Access Compliance Report

Public Rights-of-Way

Intersection ID: 49312	Main Street: MISTY_EVE_LN	Cross Street: BROOKE_NICOLE_PL	Location: W
ADA ID: 4C1B97F01A39	Ramp Type: PerpDiag	Initial Pass/Fail: Fail	Overall Compliance: No
		Severity Score: 50

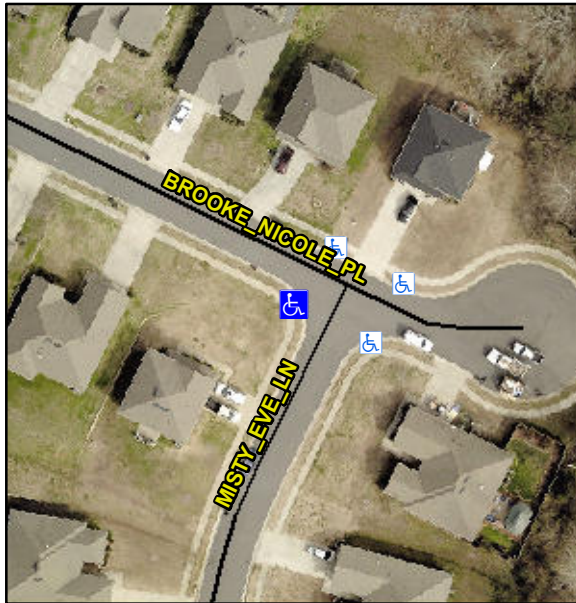
Not Found, R304.2.2, R304.5.3

Compliance	Description	Data	Compliance	Description	Data
N/A	Ramp Length (in)	47.5	No	Ramp Slope (%)	13.5
Yes	Ramp Width (in)	48.0	No	Ramp XSlope (%)	12.7
N/A	Flare Type LT	N/A	N/A	Flare Type RT	N/A
N/A	Flare Slope LT (%)	N/A	N/A	Flare Slope RT (%)	N/A
N/A	Flare Traversable LT?	N/A	N/A	Flare Traversable RT?	N/A
N/A	Landing Length (in)	N/A	N/A	DWS Provided?	N/A
N/A	Landing Width (in)	N/A	N/A	DWS Contrast?	N/A
N/A	Landing Slope (%)	N/A	N/A	DWS Length (in)	N/A
N/A	Landing X Slope (%)	N/A	N/A	DWS Full Width?	N/A
N/A	Landing Curb? (Y/N)	N/A	N/A	DWS Offset (in)	N/A
N/A	Shared Landing?	N/A			
N/A	Gutter Ponding?	N/A	N/A	Gutter Slope (%)	N/A
N/A	Gutter Lip Ht (in)	0.5	N/A	Gutter X Slope (%)	N/A
N/A	Painted X Walk1?	No	N/A	Painted X Walk2?	No
	X Walk 1 Direction	To S		X Walk 2 Direction	To N
N/A	X Walk 1 Width (in)	N/A	N/A	X Walk 2 Width (in)	N/A
	X Walk 1 Slope (%)	7.8		X Walk 2 Slope (%)	8.0
	X Walk 1 X Slope (%)	8.1		X Walk 2 X Slope (%)	8.8

Remove & Replace Curb Ramp With Two New Directional Ramps or Equivalent.
